# ADDENDUM #1

Date: 7/24/2013

Project: Window-Door Replacement/Repair  
Kiser Middle School  
716 Benjamin Parkway, Greensboro, NC

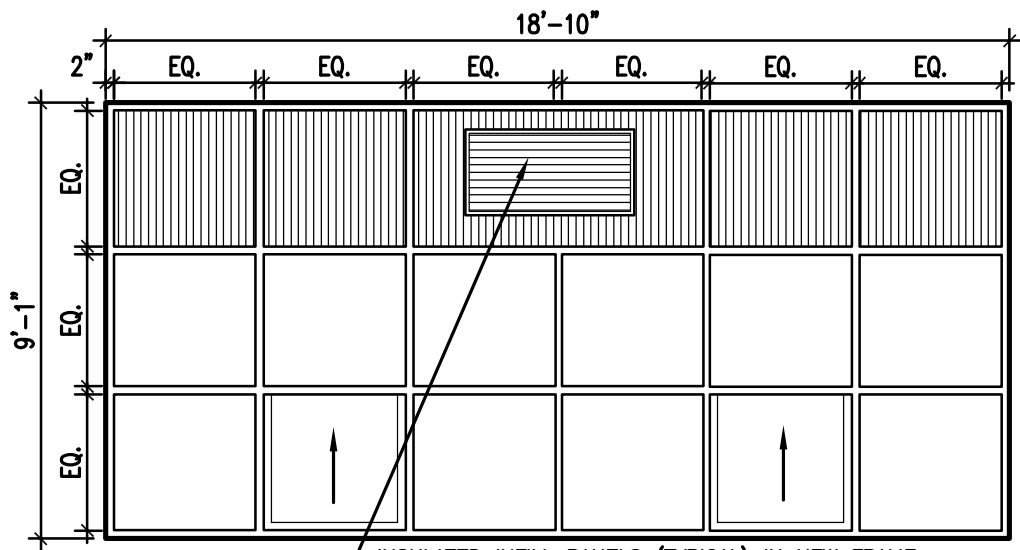
- Base Bid, Second Floor, Corridor-East Elevation, 4/A1:  
Install prefinished aluminum cladding on the exterior face of columns, between windows. Gauge and Color are to match installation on the floor below.
- Alternate 1, Lower Floor, Cafeteria-West Elevation, 5/A1:  
Existing HVAC Louver is to be maintained and reinstalled in the new insulated panel. Seal all joints. Please refer to the bulletin drawing, Window Elevation W6A. **ADD** sleeve at grill penetration (as required).

INSULATED INFILL PANELS (TYPICAL) IN NEW FRAME.  
 SEAL JOINTS. MAINTAIN AND REINSTALL EXISTING LOUVER.  
 ADJUST CONNECTION AS REQUIRED. SEAL JOINTS

**(UNIT PRICE U-3, INCLUDES (2) W11)**  
**8**  
**A3** 1/4" = 1'-0"

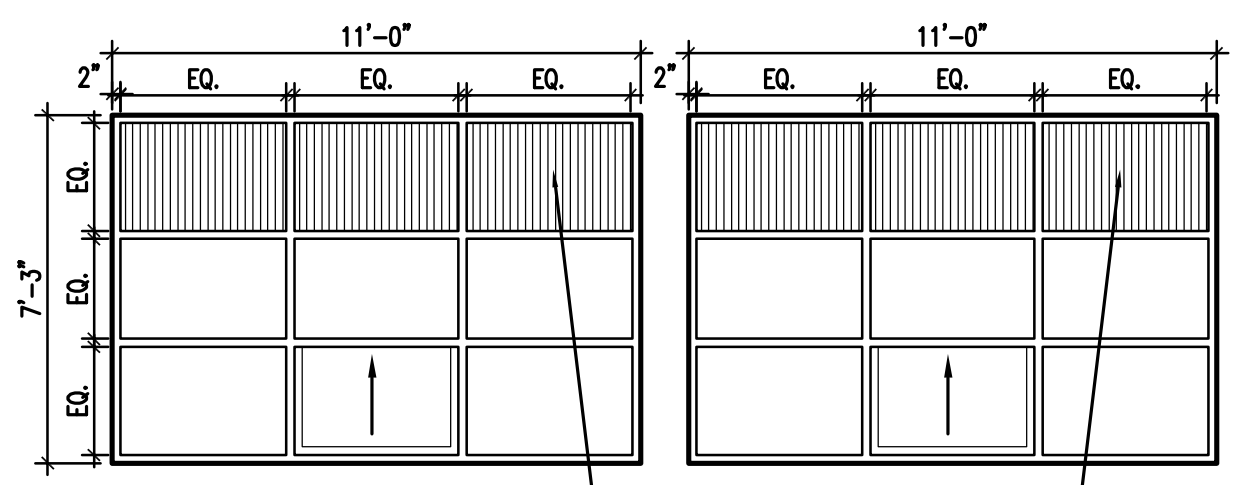
- C. Refer to A3:  
Added Unit Price U-3, **TWO units of Window Type W11**, located in Classroom Buildings A and B. Please refer to the revised Key Plan and window elevation for Unit Price U-3 on Sheet A-3 attached with this Addendum. Also attached is the revised Specification Section 01 22 00 (Unit Price Form to be submitted with the Bid Form).

INSULATED CLEAR ANODIZED ALUMINUM WINDOW FRAME (THERMALLY BROKEN) w/SINGLE HUNG OPERABLE WINDOW AND TUBULAR VERTICAL MULLIONS  
 ADDENDUM-1, JULY 24, 2013  
 KISER MIDDLE SCHOOL WINDOW REPLACEMENT  
 INCLUDE TYPICAL STONE SILL IN THIS UNIT PRICE

**6 TYPICAL SILL AND HEAD DETAILS**  
**A3** 3" = 1'-0"

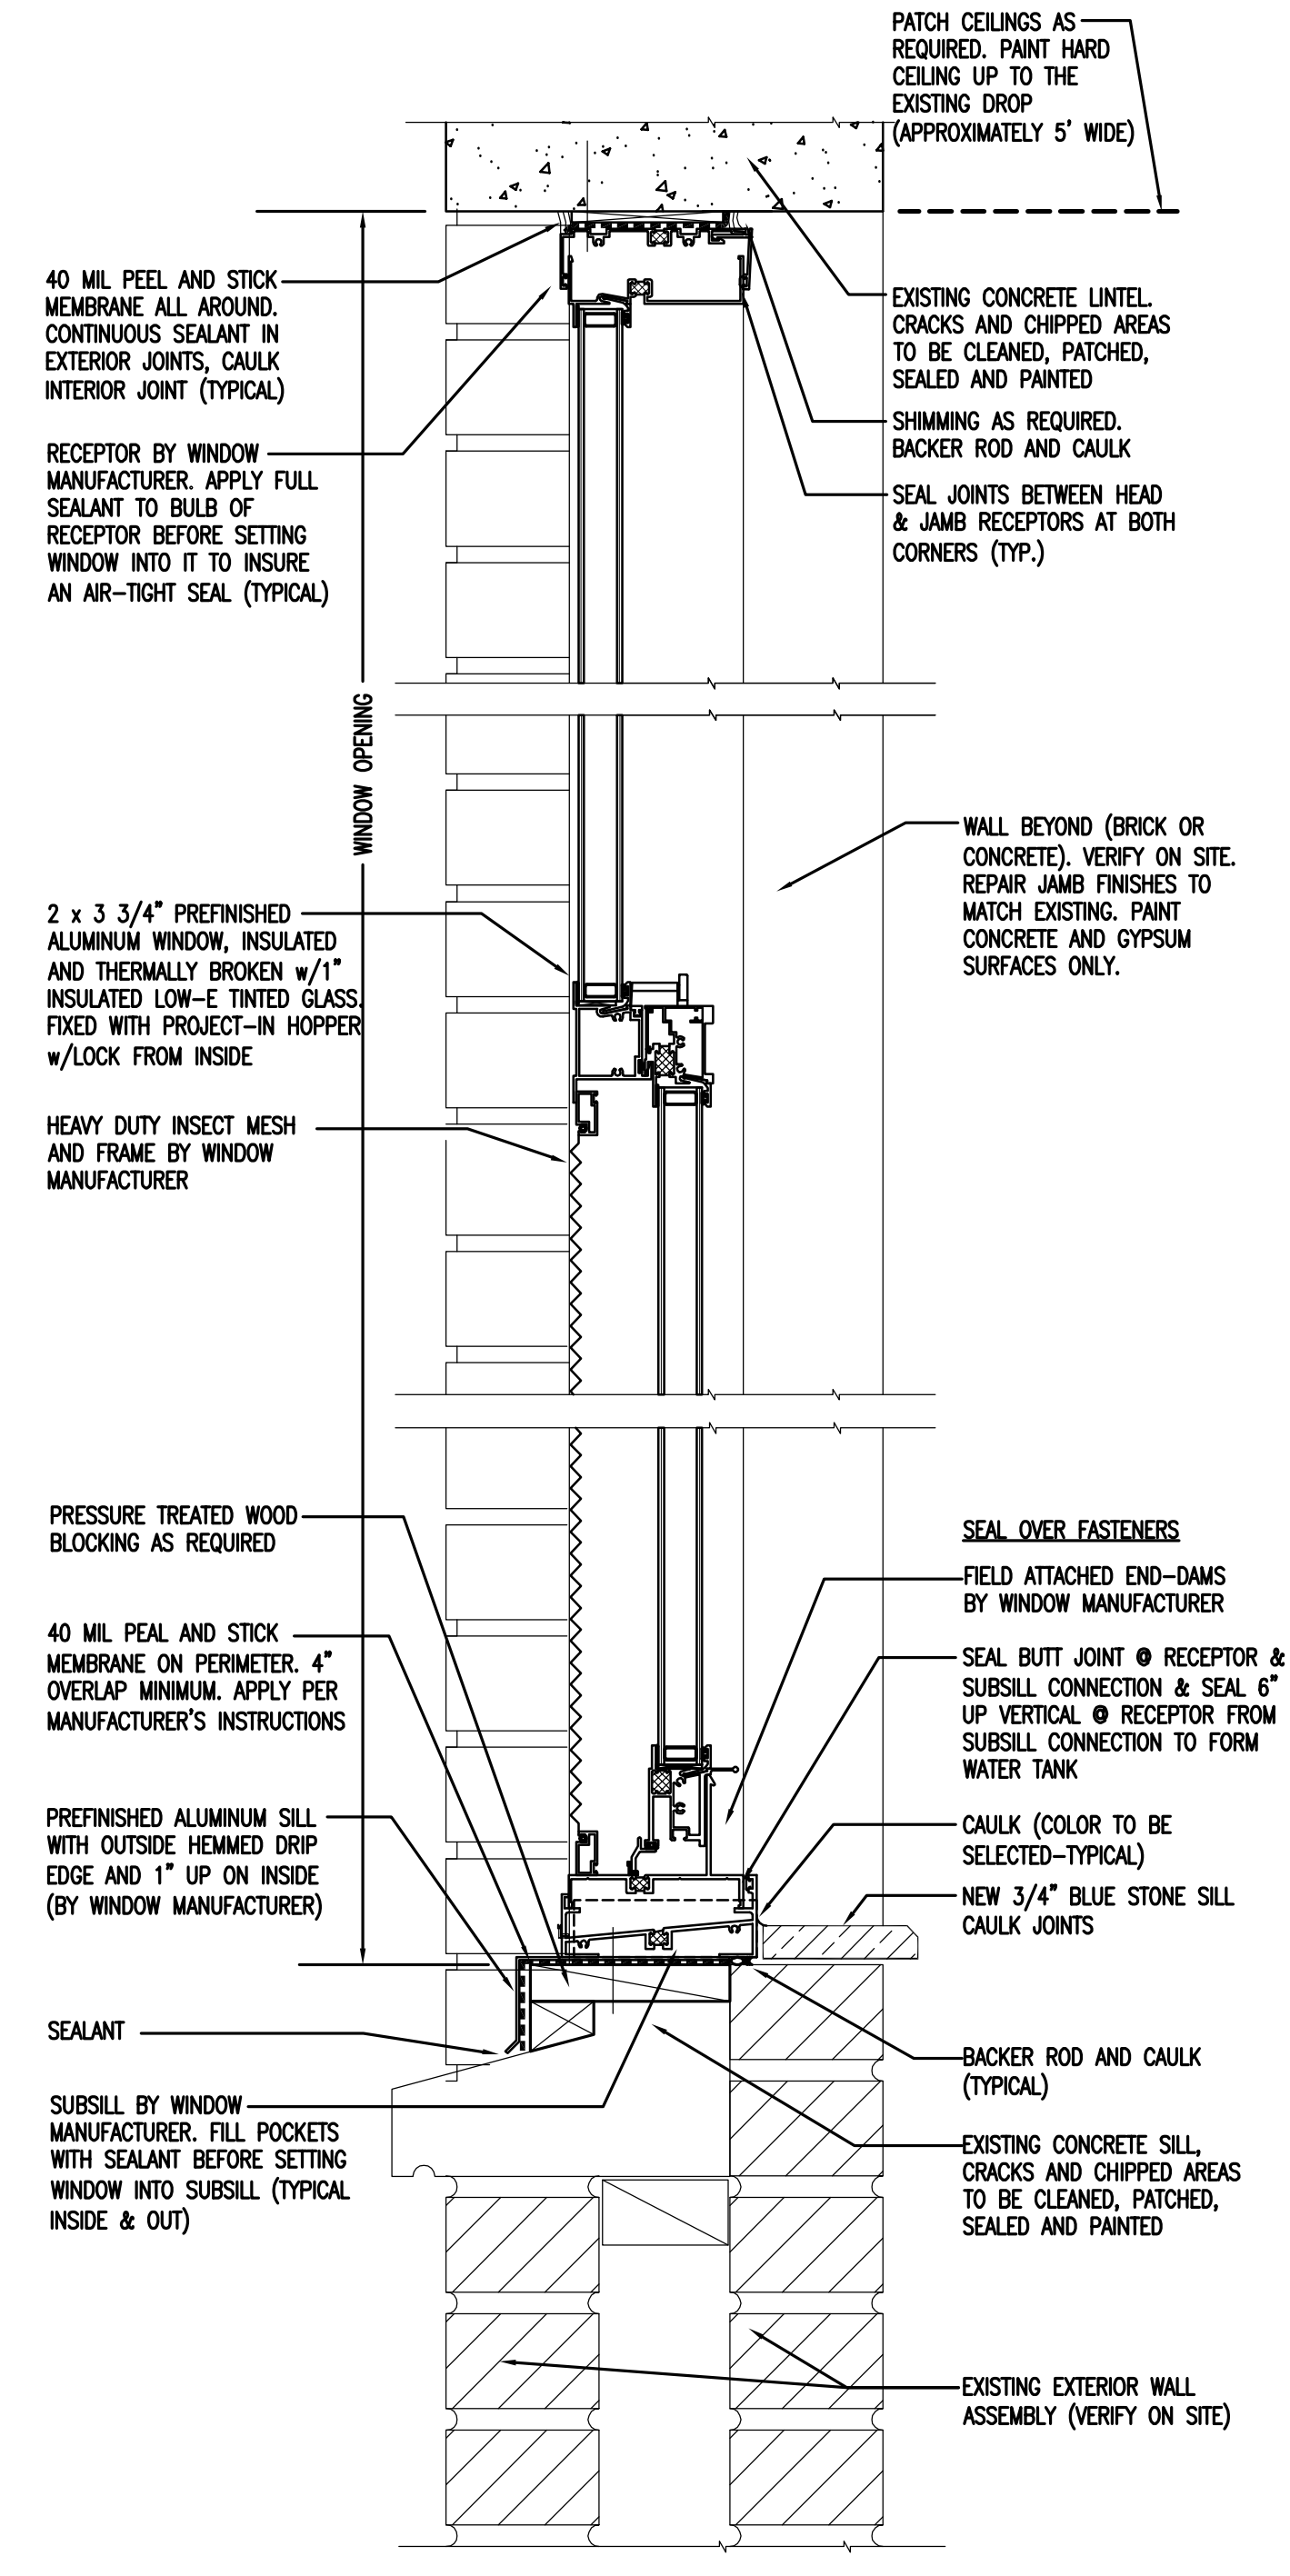
- G. New 3/4" blue stone sill as shown and noted Details 6/A2 and 6/A3.
- H. Change Glass Shading Coefficient to 0.27. Color to be Green Tint.
